AGENDA

Village of Chenequa Plan Commission
Monday, May 12, 2025 at 6:00 p.m.
31275 W. County Road K, Chenequa, WI 53029

STAFF REVIEW

Subject: Site Plan Review

Hansen
Remodel
Existing & New East Elevation

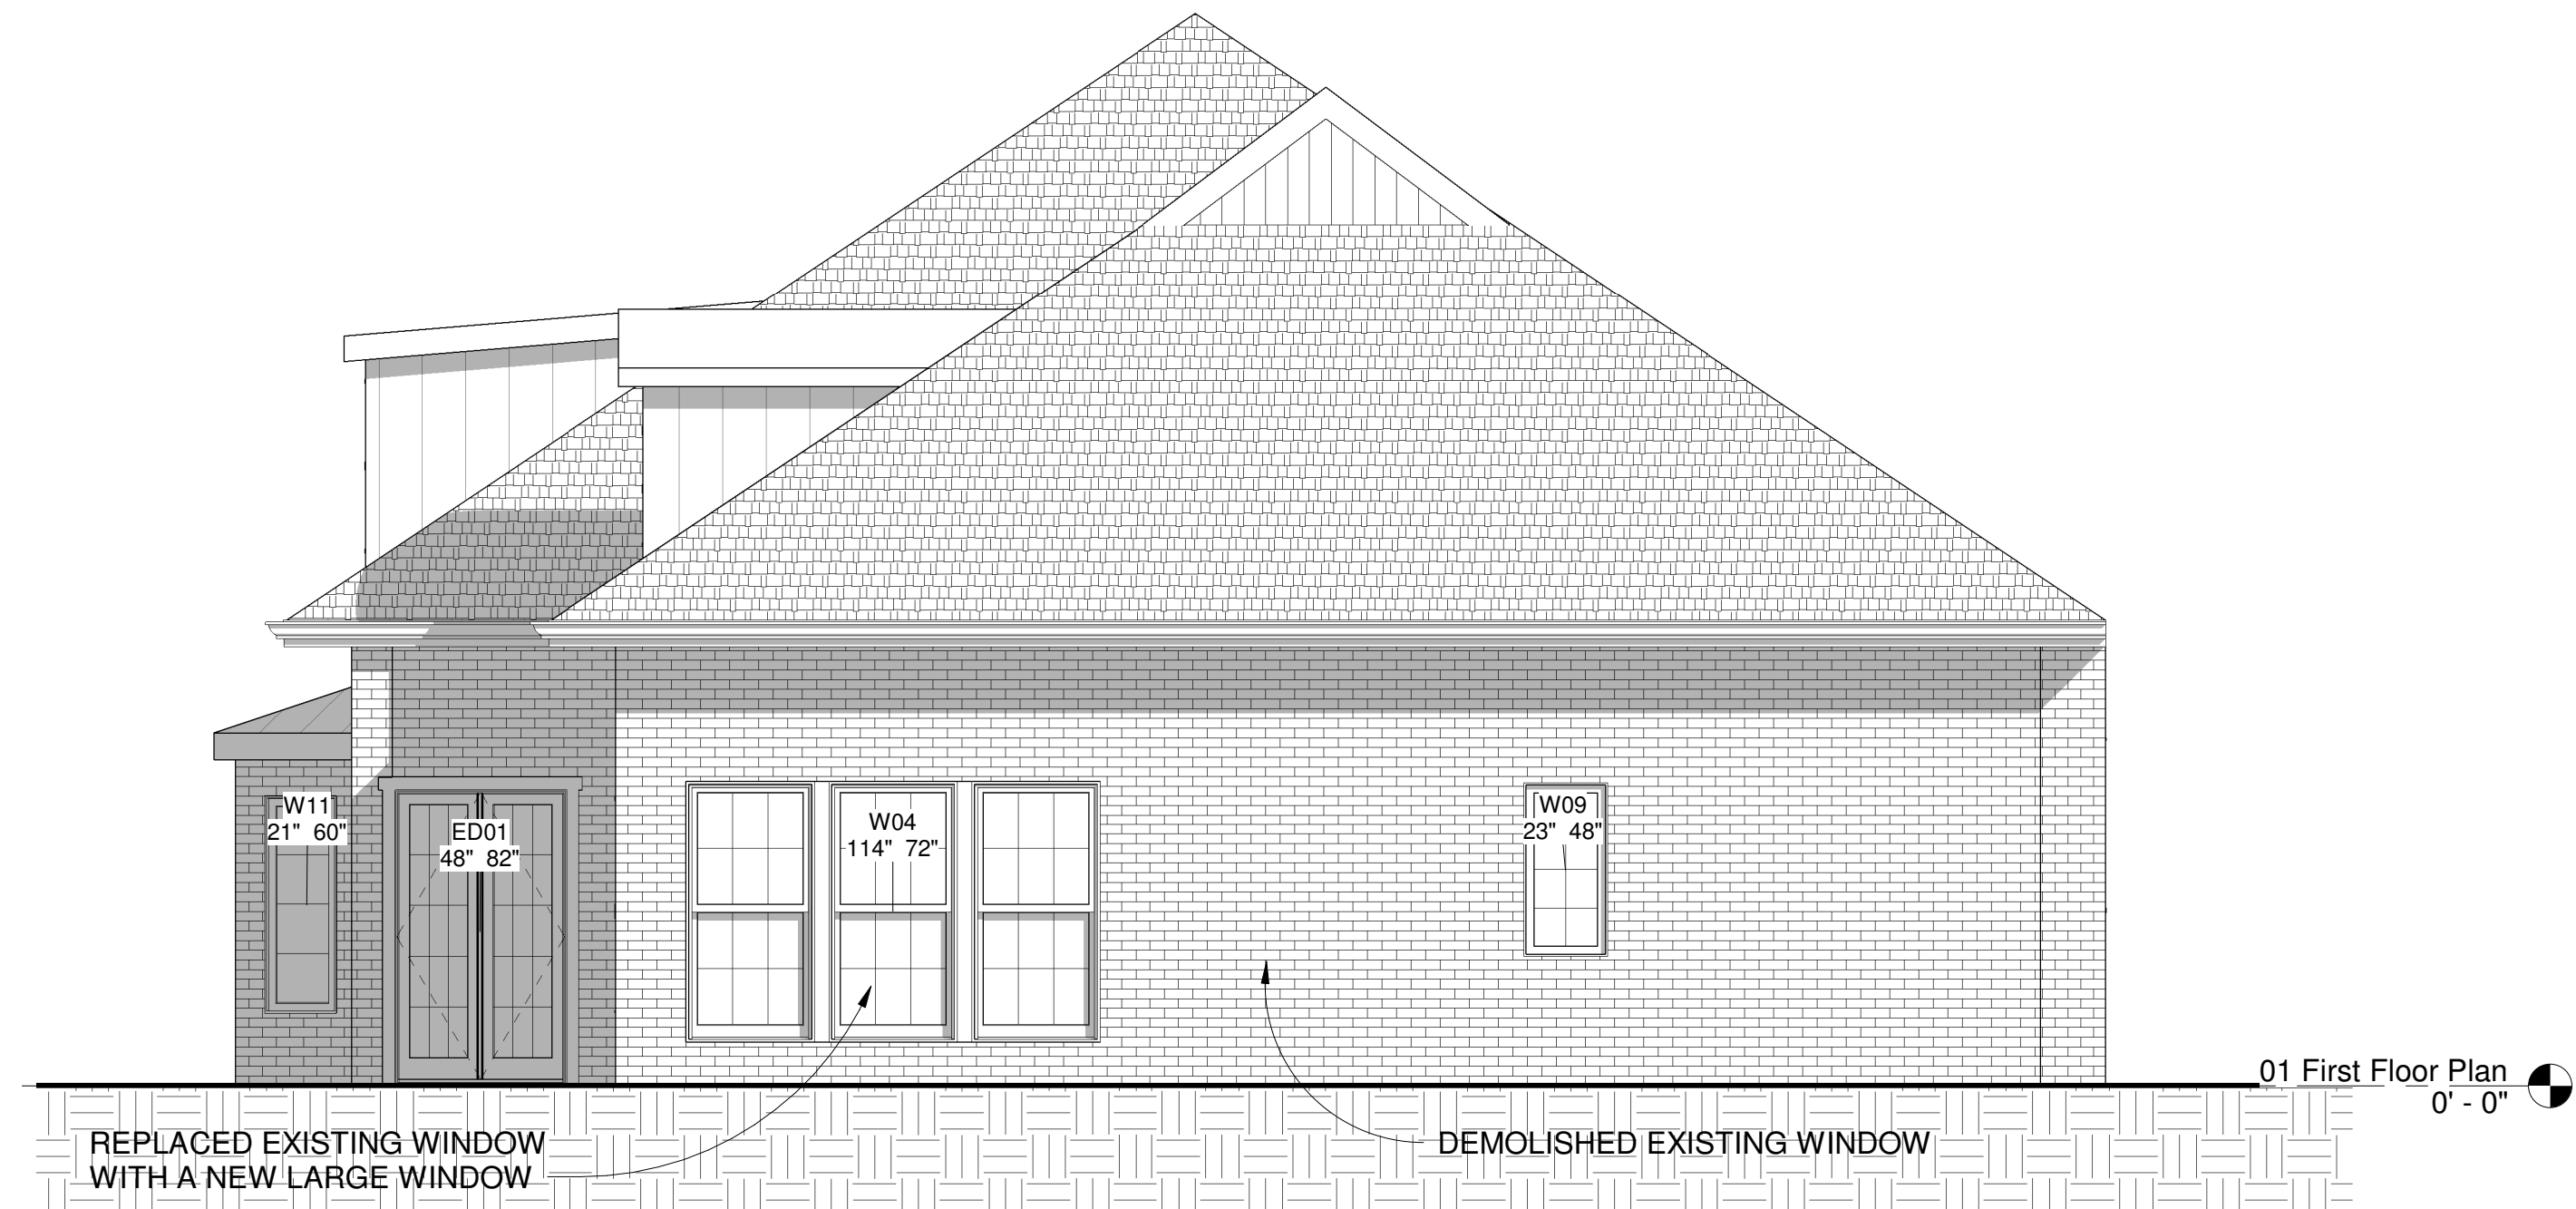
The applicant Judy Hansen is proposing to make several minor modifications to her existing dwelling on Pine Lake, as detailed in the plans labeled A200 and A201. These plans highlight new window/door systems on the lakeside elevation. Additionally, along the east elevation the applicant proposes to replace an existing window with three larger double hung windows. On the same elevation, the plans also propose to remove an existing 23"x48" window.

These modifications do not alter the footprint or overall size of the house.

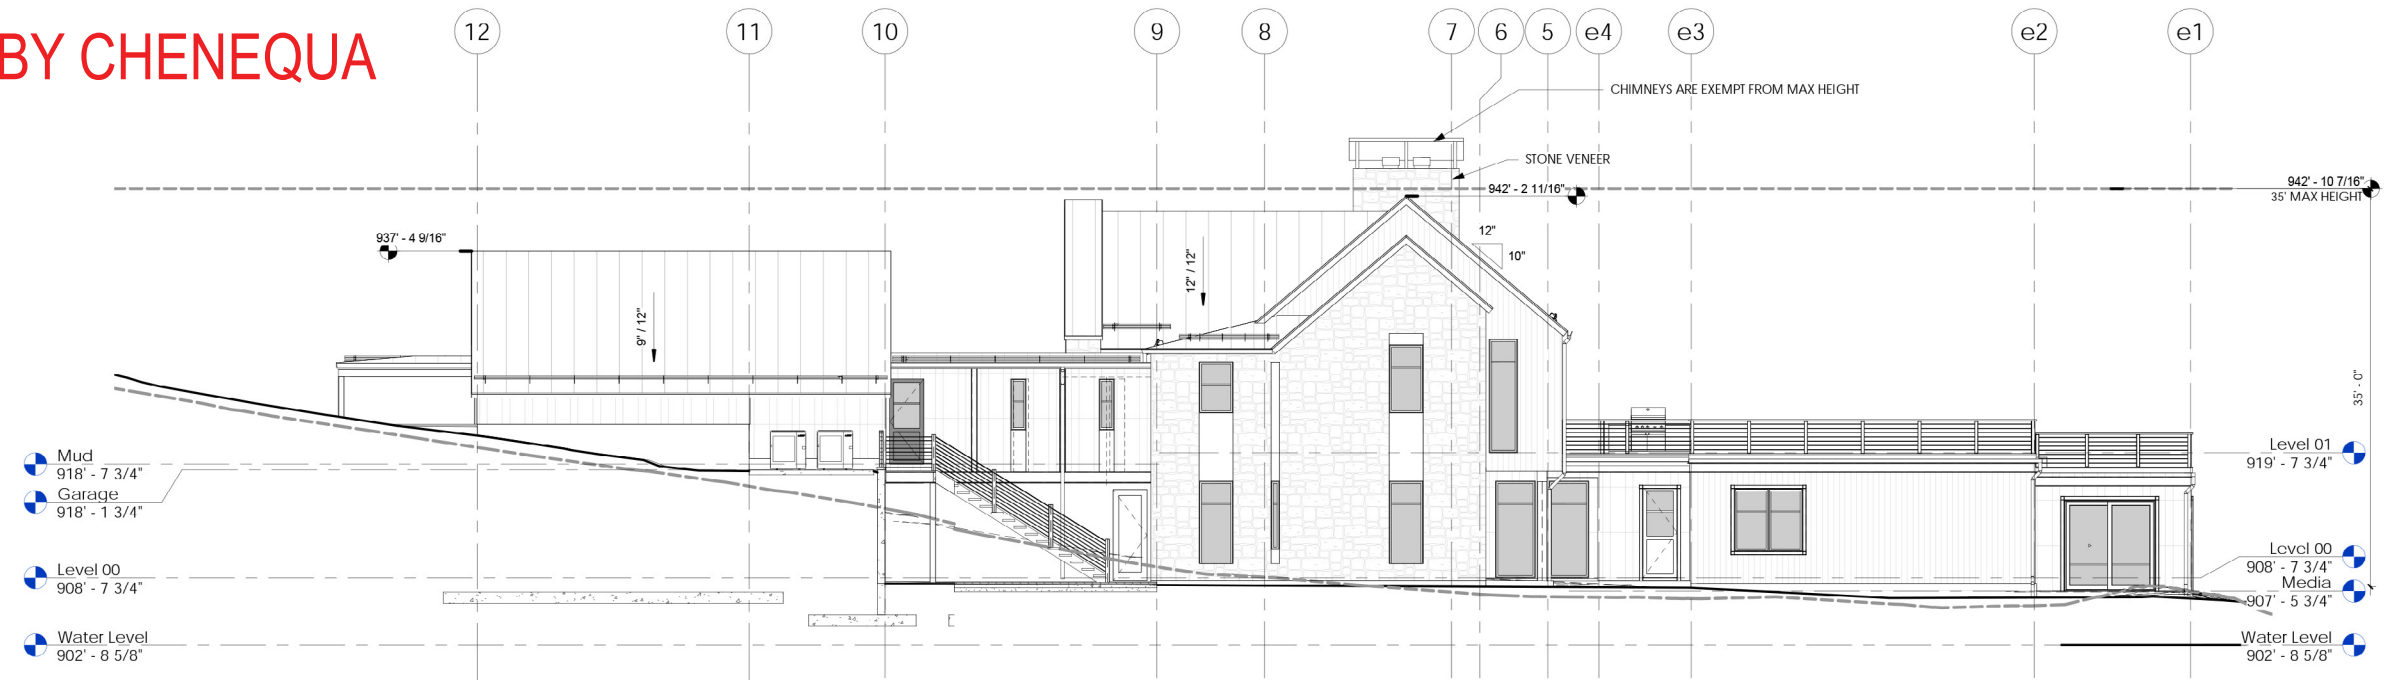
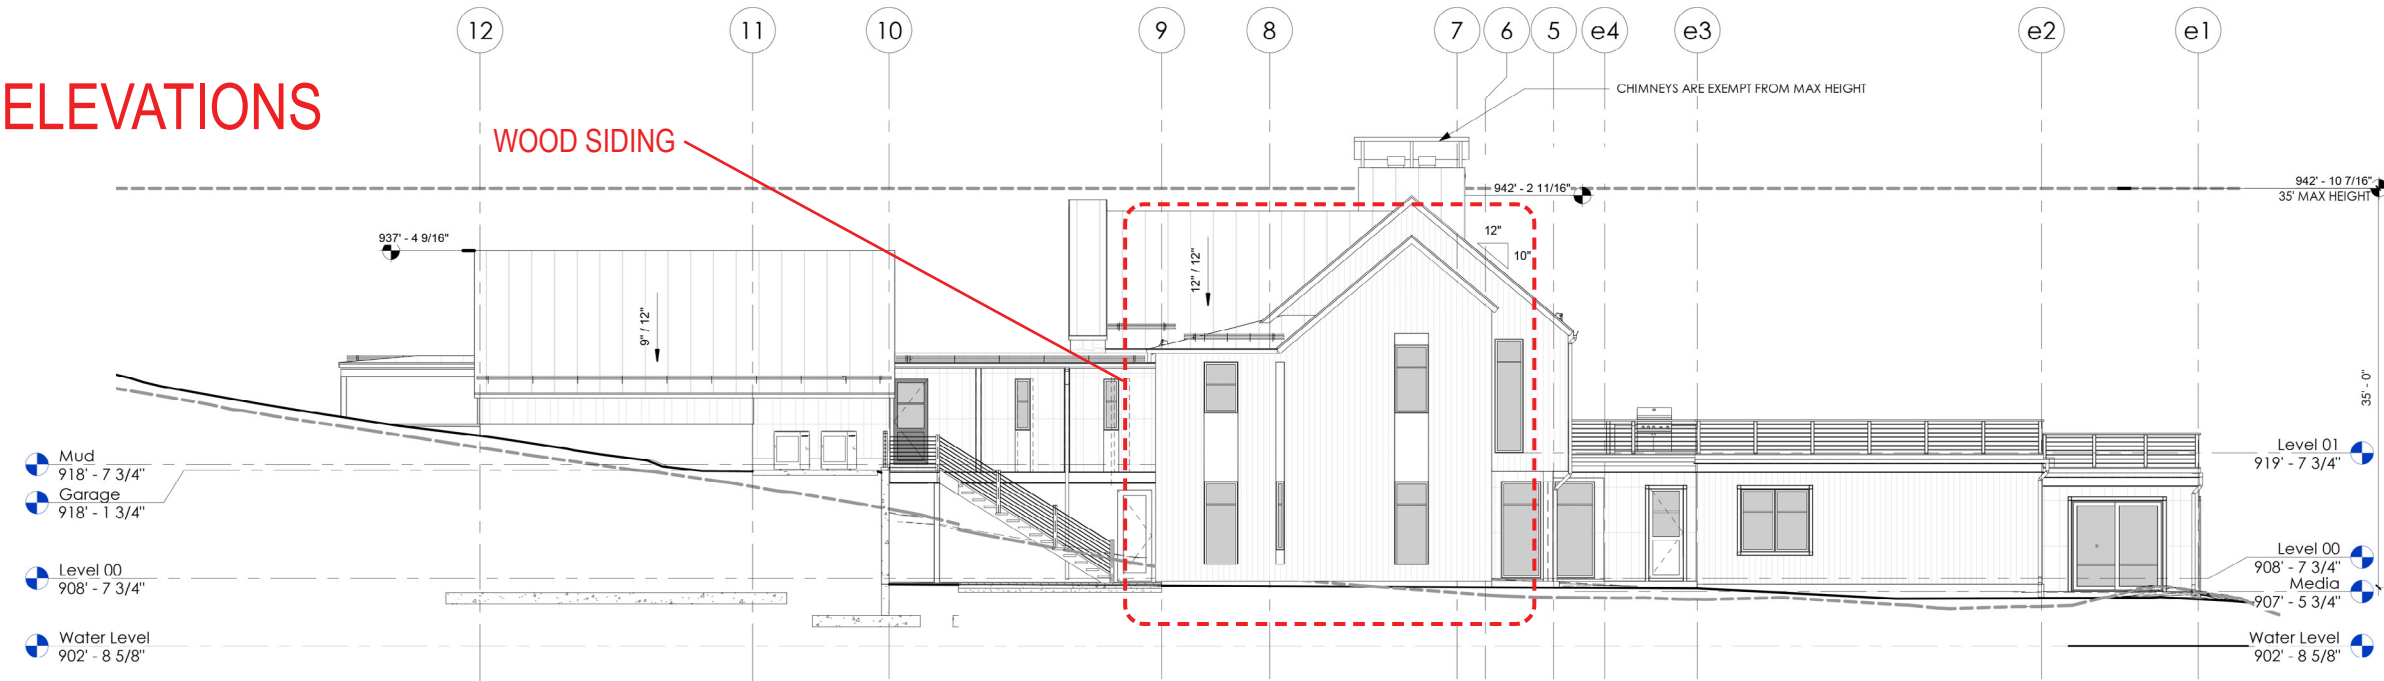
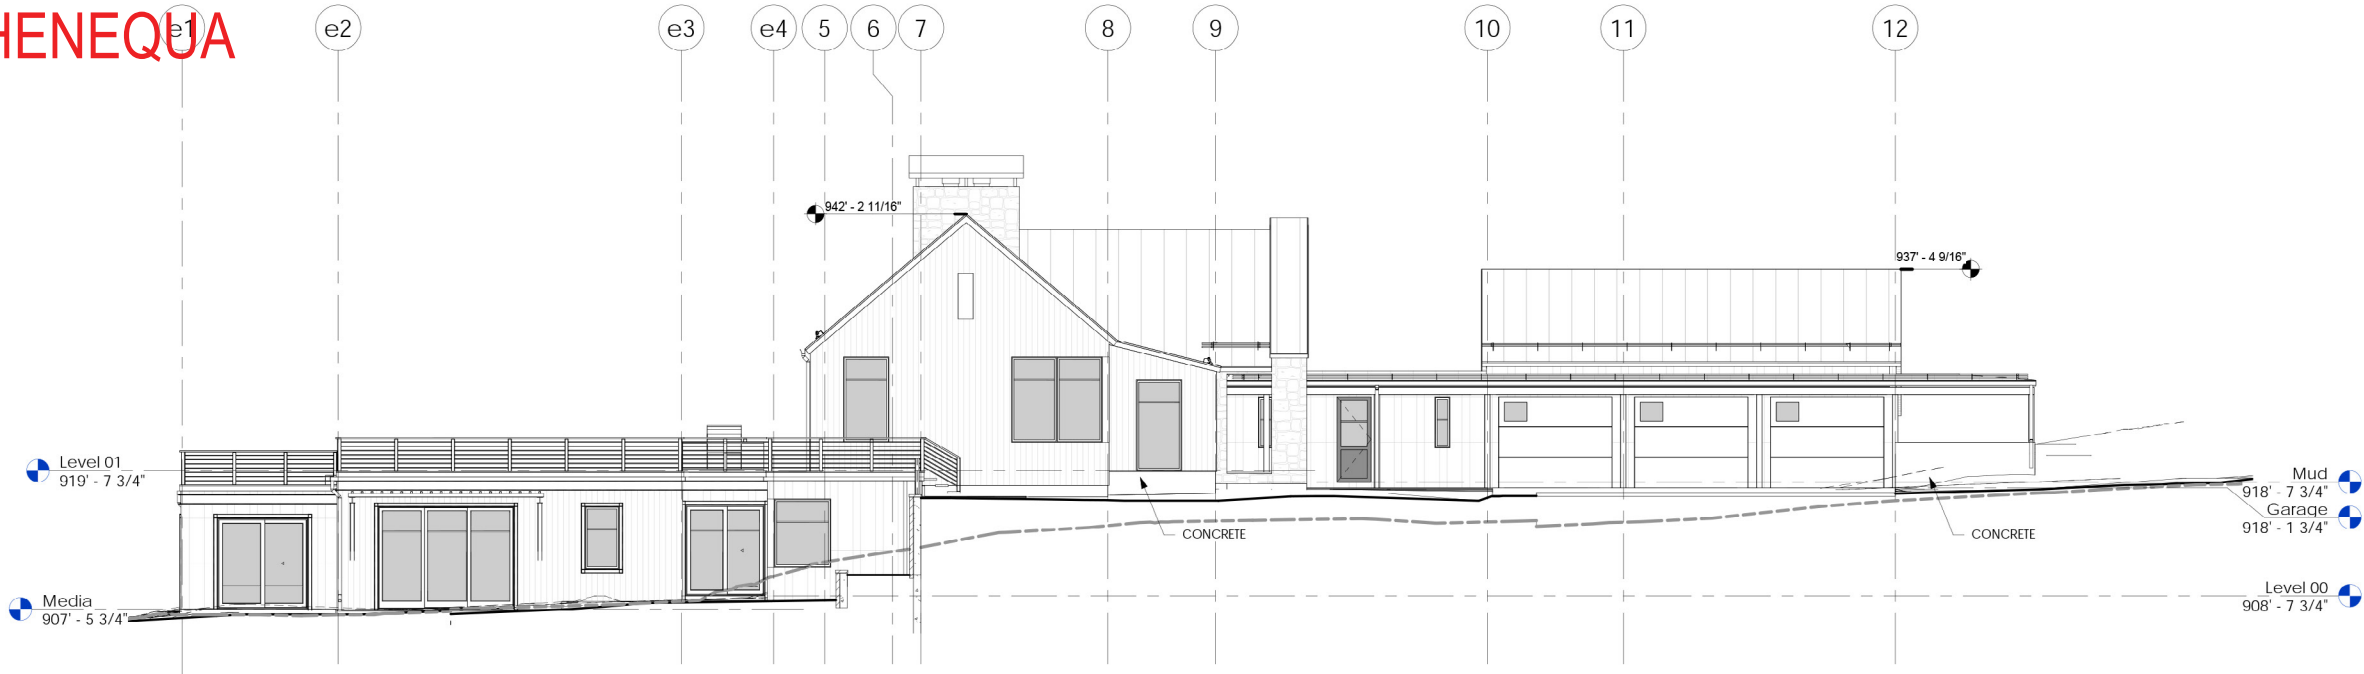
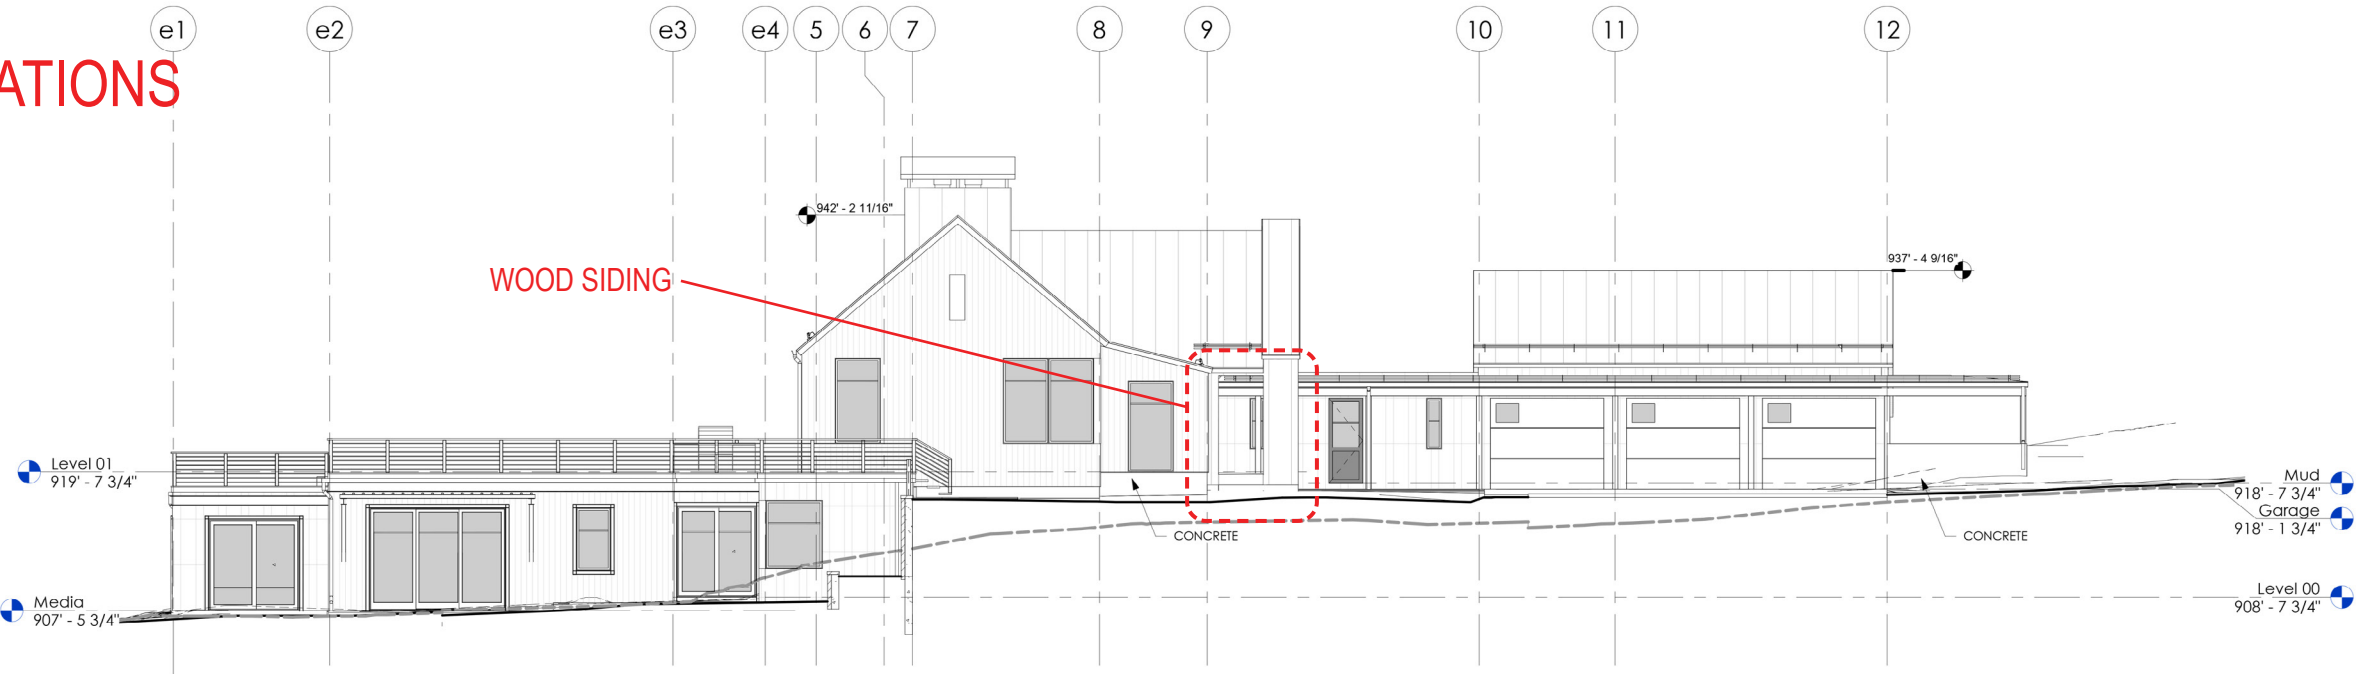
In September of 2023, John and JoJo Neumann received approval from the Village board for an addition/remodel project at 5777 N State Road 83. Since these plans were originally approved, the builder has made some minor modifications. Accordingly, these changes will need to be approved.

The changes proposed are minor, however will affect the exterior appearance of the home. The plan set provided shows elevations of both "Approved by Chenequa" and "Proposed Elevations". The respective changes are circled or highlighted in red. All proposed changes involve replacing previously approved stone with either wood siding or metal siding. These changes shown do not result in an increased footprint, living area or structure height. Photo samples of the proposed new materials have been included in the packet.

Proposed Accessory Structure

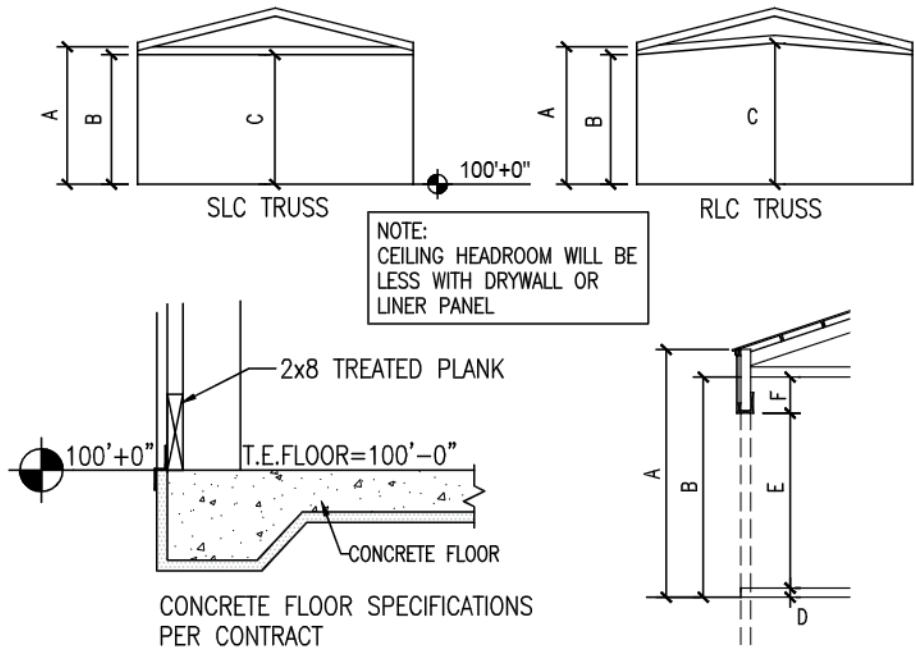
1. The applicant proposes to construct a single-story accessory structure.
2. The dimensions of this proposed accessory structure are 40'x 72'
3. The total square footage of this structure is 2,880
4. The building plans accommodate for a future bathroom and mechanical room.
5. This structure is proposed to be sheathed with a "surrey beige" steel siding with a "territone brown" steel roof.

- a. The primary dwelling on the property has a stucco finish. While the exterior color of the proposed accessory structure is similar, the materials are different.

6. There are currently no known accessory structures on the property
7. 6.5(c) specifies that “The maximum footprint of all accessory buildings erected, modified or moved on any lot shall not exceed two percent of the total lot area.

- a. The maximum allowable footprint of all accessory buildings on this property is 7,161 square feet.
8. There is no cooking or sleeping quarters proposed for this structure

9. The proposed detached accessory structure is over one hundred (100) feet to any existing single-family structure on an adjoining lot which complies with section Sec. 6.5(c)(i).
